Millennium Mine

It is advised that MetRes Pty Ltd has lodged an application for a major amendment to an environmental authority in accordance with the requirements of the *Environmental Protection Act 1994*. The environmental authority being amended is EPML00819213.

The submission package under assessment is the proponents response to an information request (IR) received by the administering authority on 15 August 2024.

**Millennium Coal Mine EPML00819213
Environmental Authority amendment
Information Request Response**

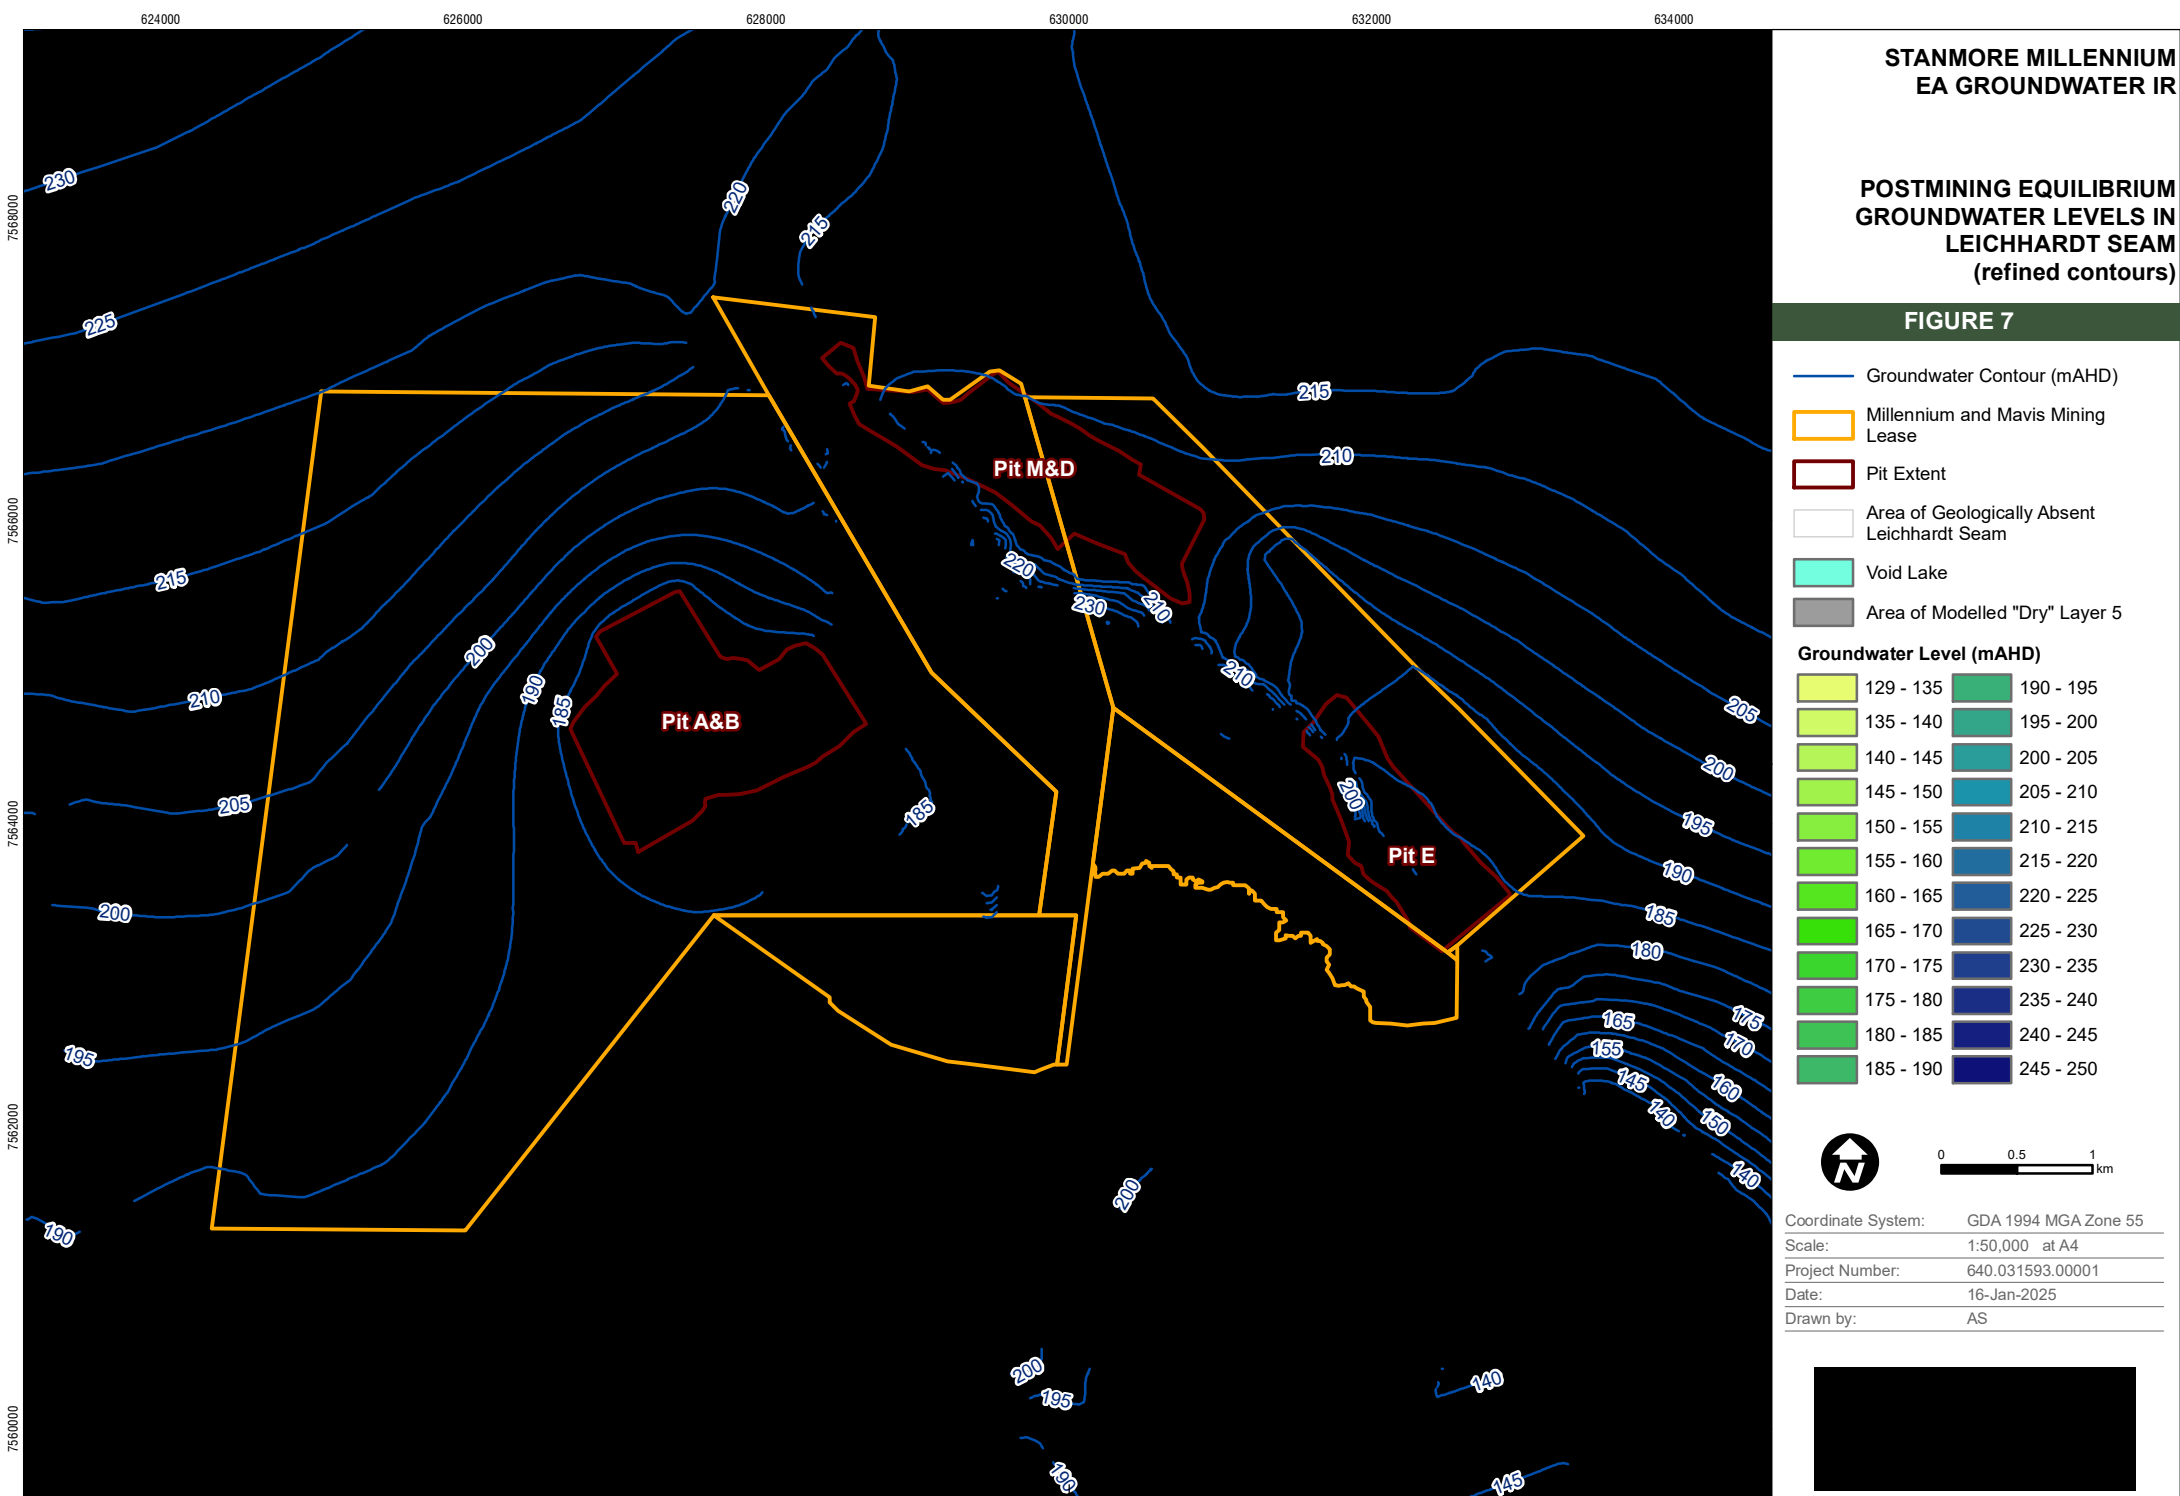
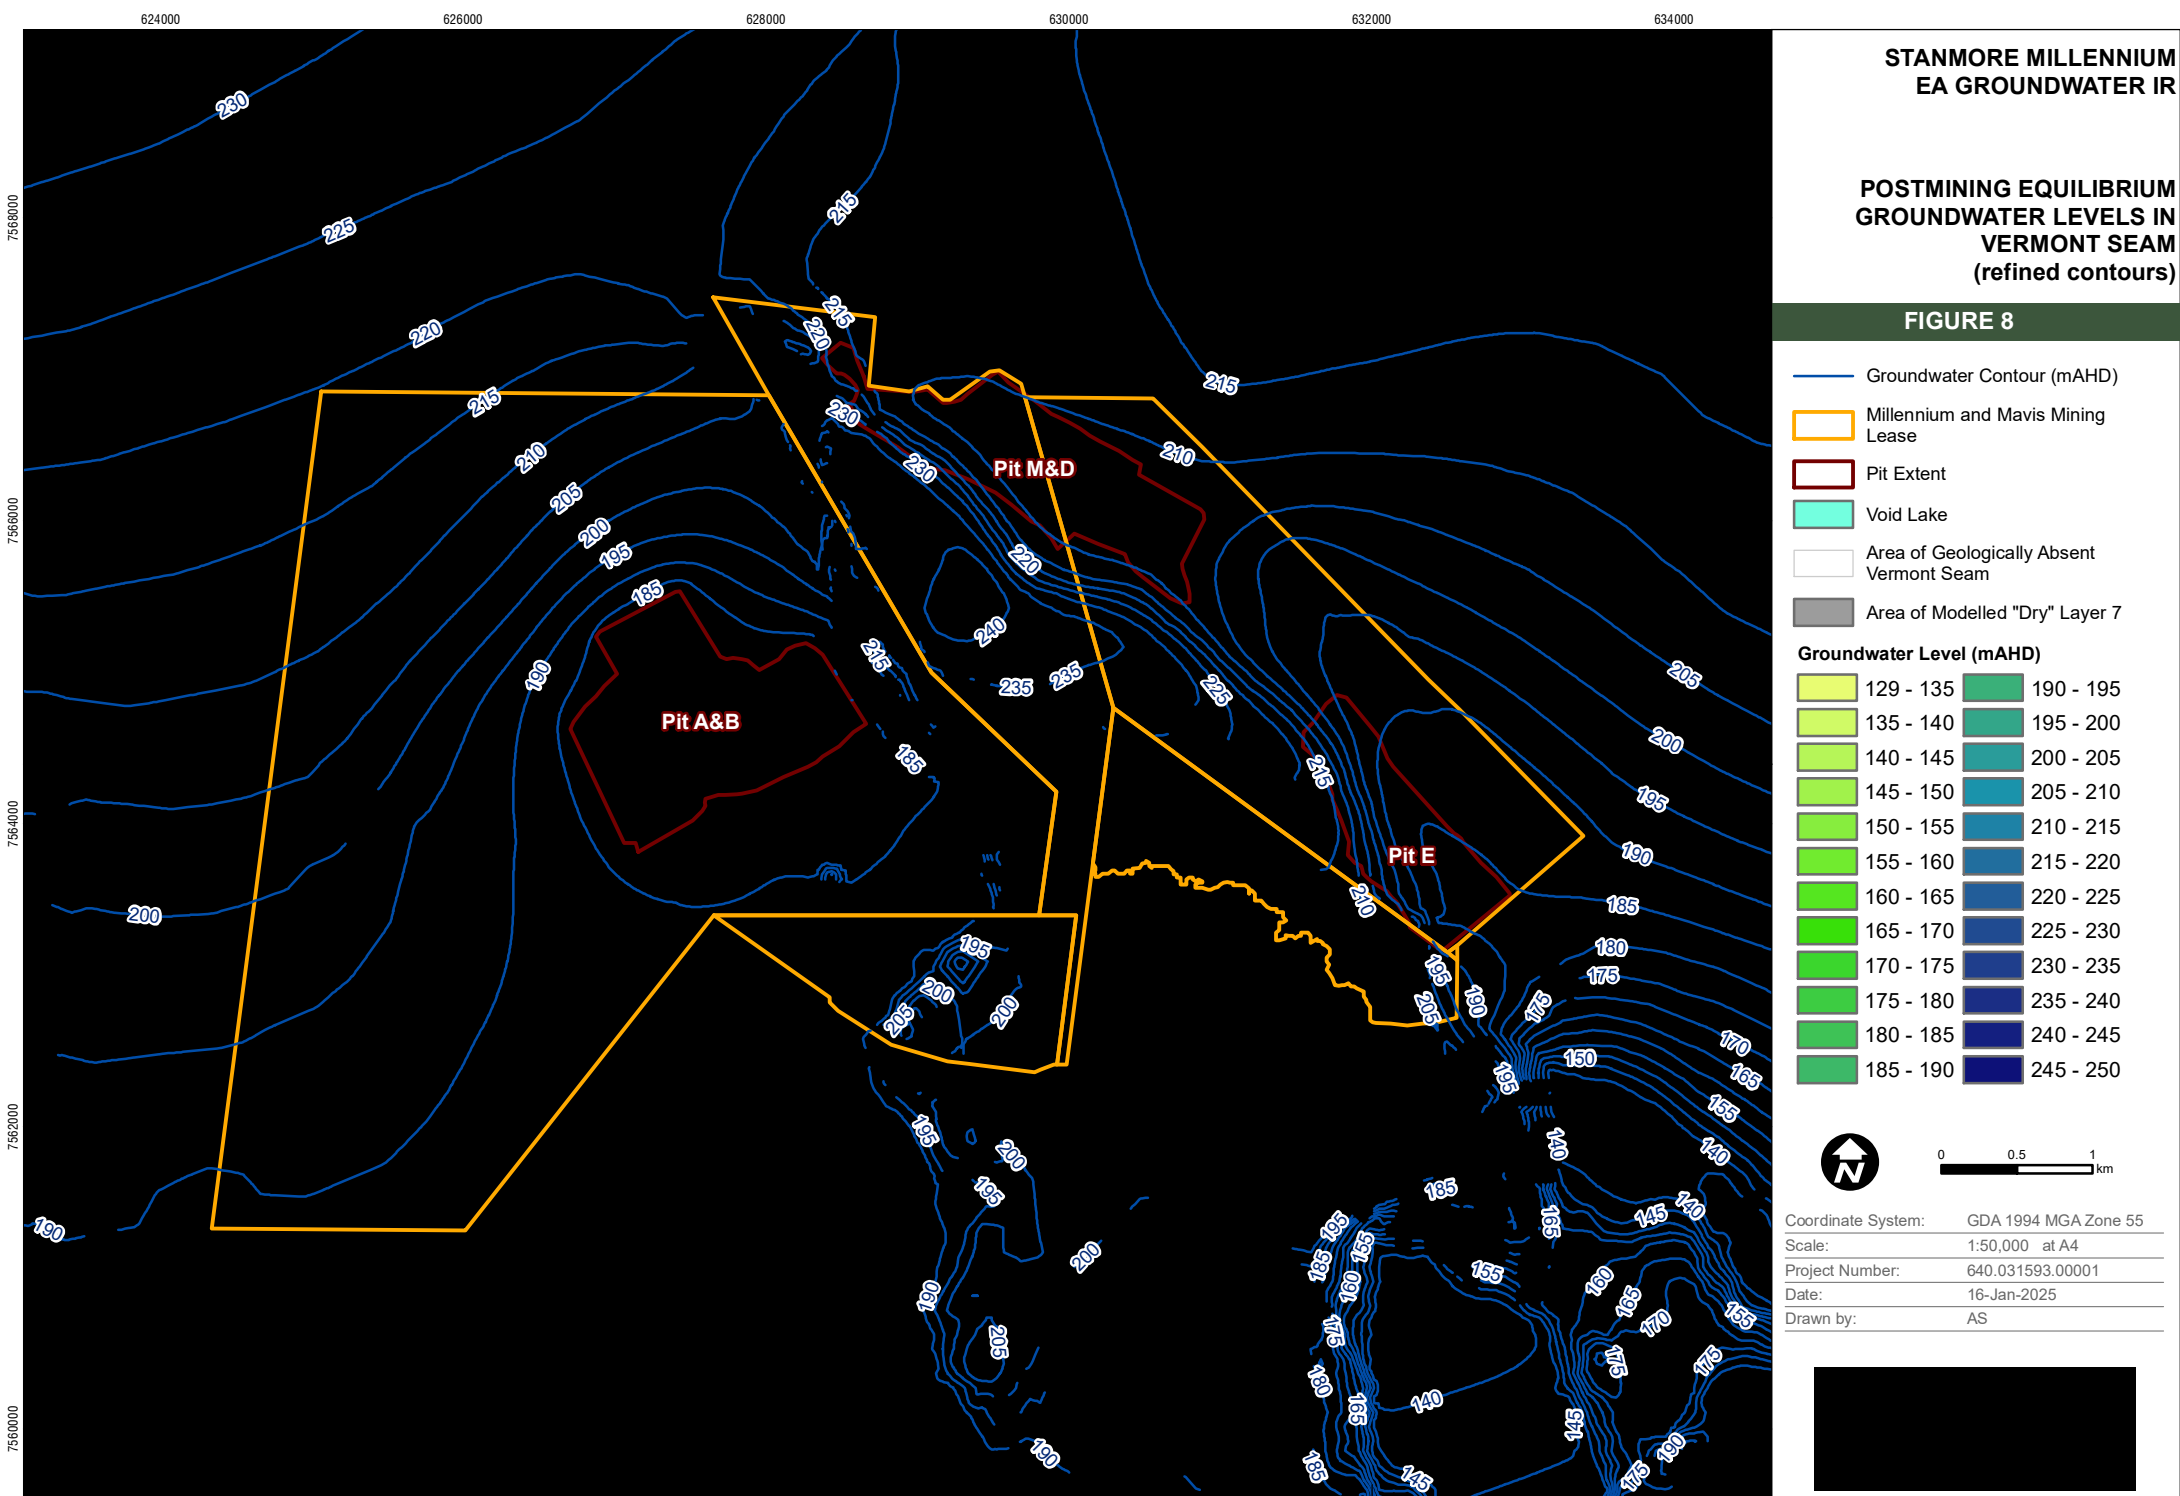
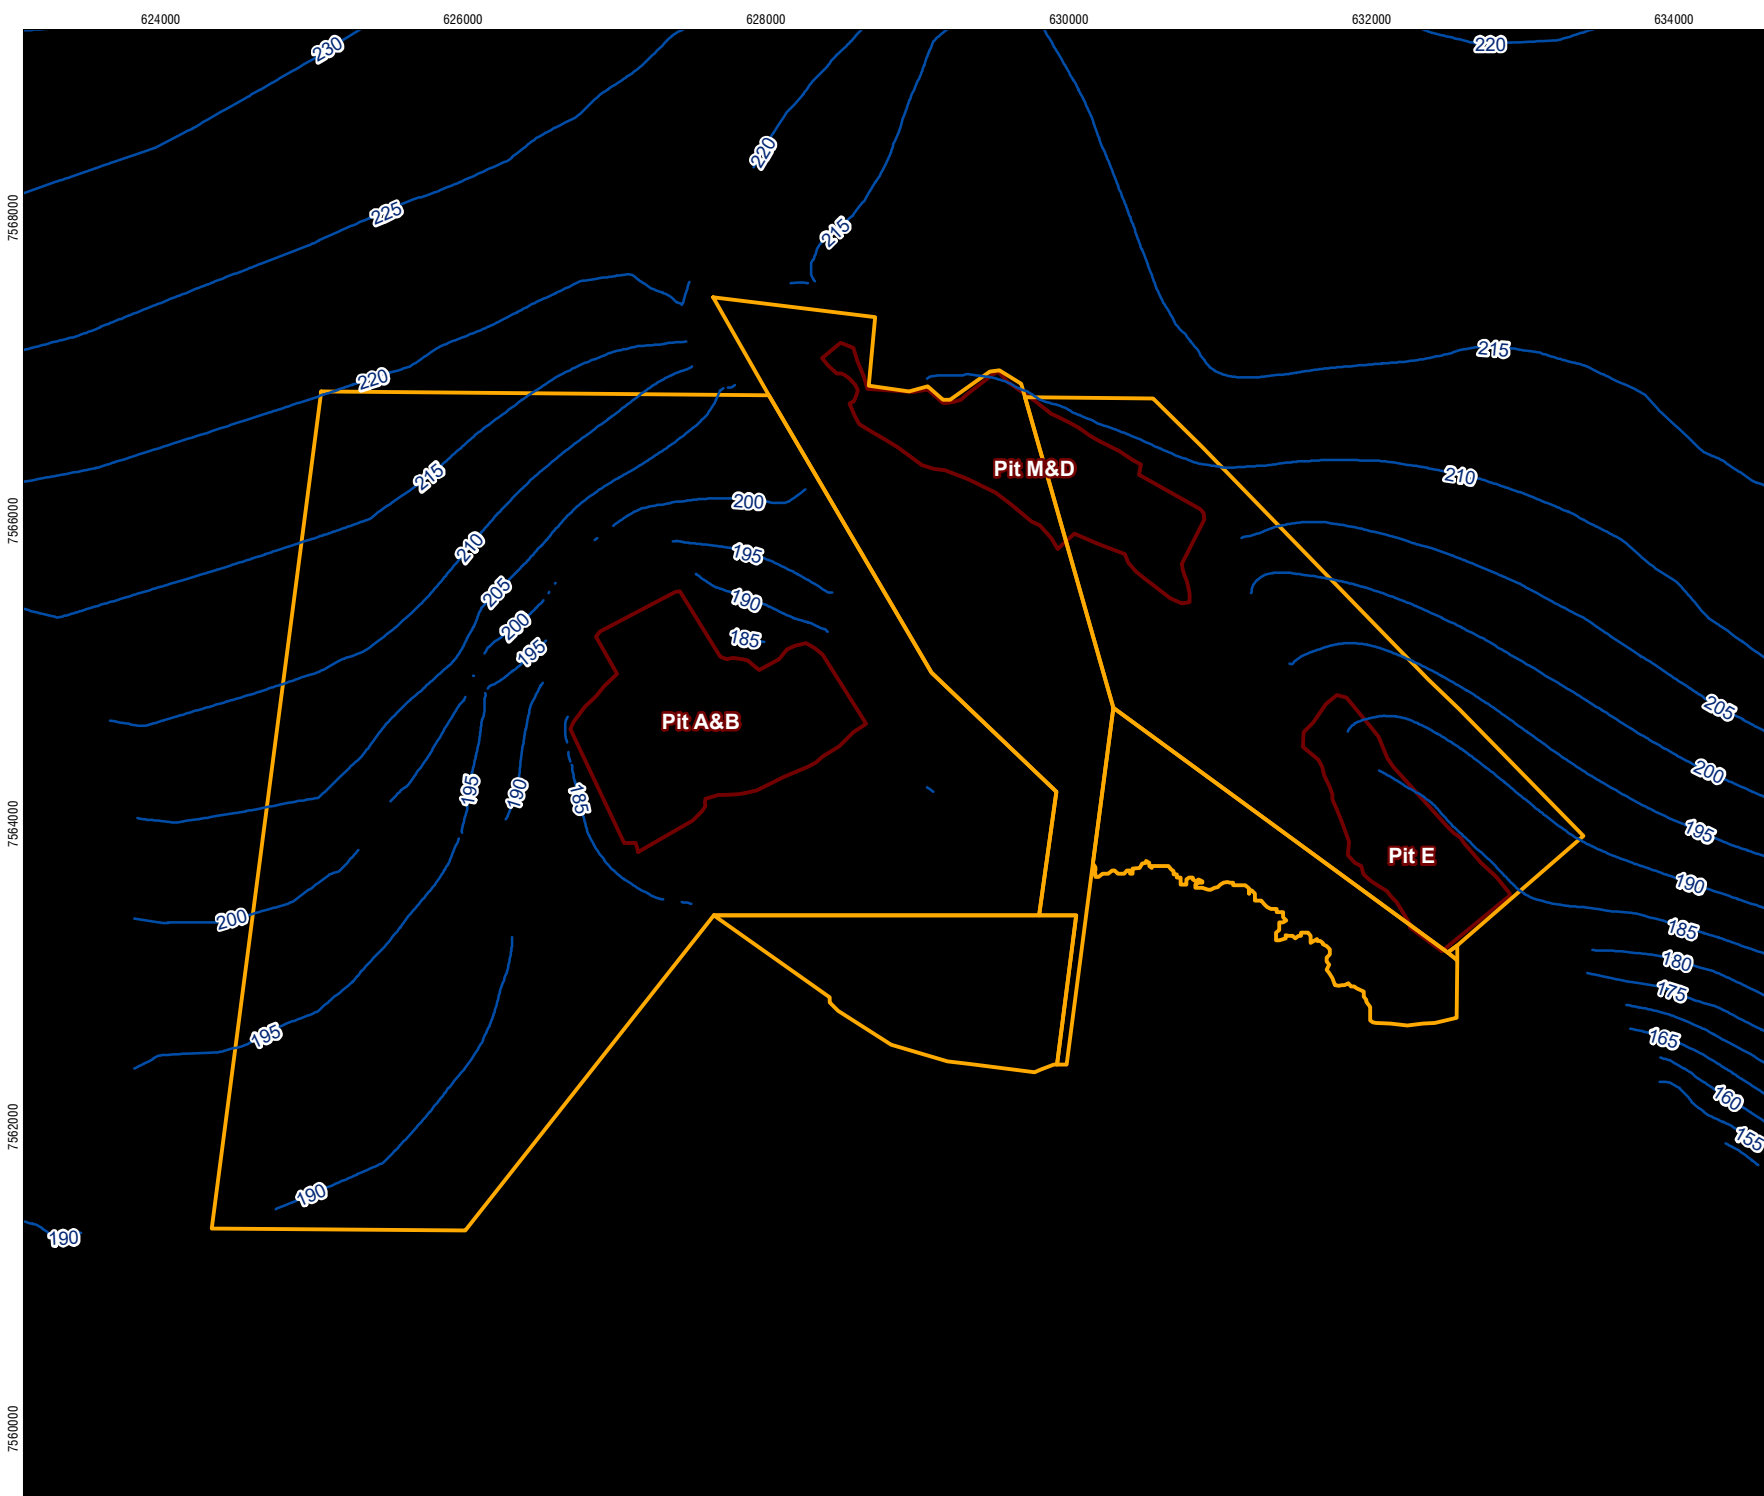
12	<p>Void Water interaction – Interaction of void water with surrounding aquifers Provide the following:</p> <ol style="list-style-type: none"> a) More detailed groundwater elevation contours for Figures 6-10, 6-11 and 6-12. b) Additional contours for the Rewan Formation, to better understand potential groundwater flow directions off lease. c) Advice as to how potential contaminants in groundwater can be stopped from leaving the mining lease area. 	<ul style="list-style-type: none"> • Groundwater elevation contours for post-mining equilibrium water table, Leichardt seam, and Vermont Seam have been provided in Figures 6, 7 and 8 with greater contour resolution. • Figure 9 provides groundwater contours for the Rewan Formation. • Discussion pertaining to movement of potential contaminants in groundwater from the mining lease area has been provided. • 	1.9
13	<p>Groundwater Exceedances, Condition D4.0 Provide the following:</p> <ol style="list-style-type: none"> a) If the three (3) exceedances condition is to be adopted for all bores and all parameters, provide more groundwater monitoring data for the bores which do not currently have 	<p>IRIRA review of the entire network trigger levels has been undertaken to support this item. This occurred in conjunction with the investigation for the following as requested:</p> <ul style="list-style-type: none"> • MB9A: Molybdenum 	1.10

- a) Please see amended Figures (here as **Figure 6**, **Figure 7** and **Figure 8**) provided below with groundwater contours refined my 10 metres to 5 metres .
- b) Please see additional figure, **Figure 9**, below for Rewan Formation.
- c) The particle tracking methodology was set up to place particles in the middle of the first saturated water column in the model. Refer to Figure 6-13 of the PRCP Appendix G for location and layer of the starting points.

Figure 11 MB9A – Aluminium data and trend analysis

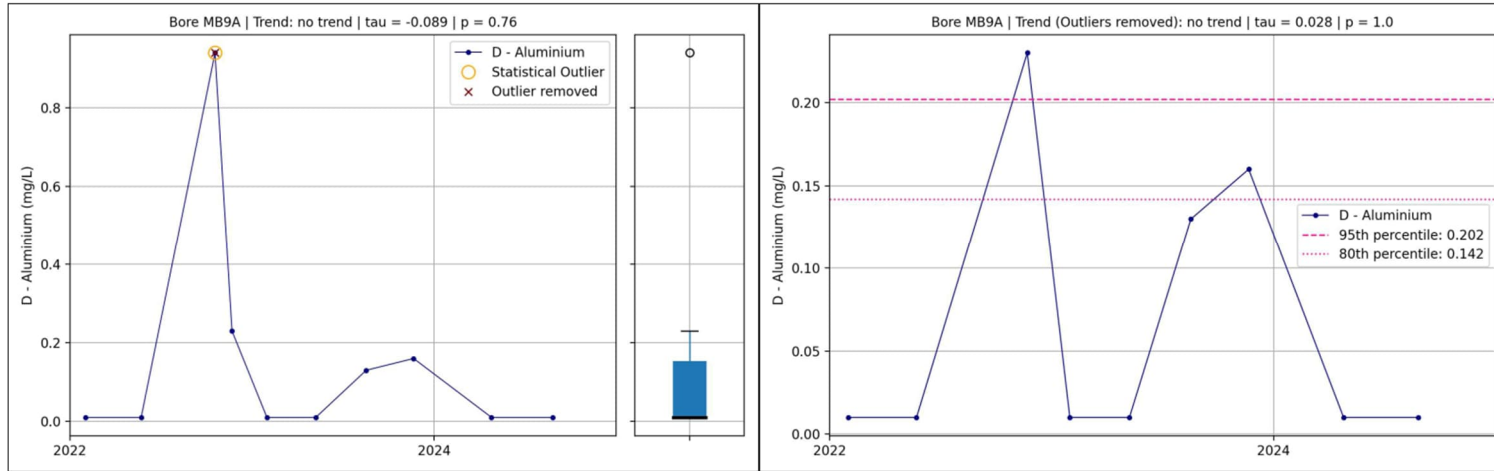
- If the three (3) exceedances condition is to be adopted for all bores and all parameters, provide more groundwater monitoring data for the bores which do not currently have sufficient data points to allow derivation of bore specific values.
- Confirm if agree to maintain default guideline values and relevant trigger exceedance limit as per current Condition D4.0 for bores which do not have sufficient data to derive bore specific limits
- Explain the increasing Aluminium trends in bores MB9A and MB9B

- c) The apparent observed increasing Aluminium trends in bores MB9A and MB9B, noted as two points trending upwards in late 2023, has since ceased, with stable parameters observed in 2024.
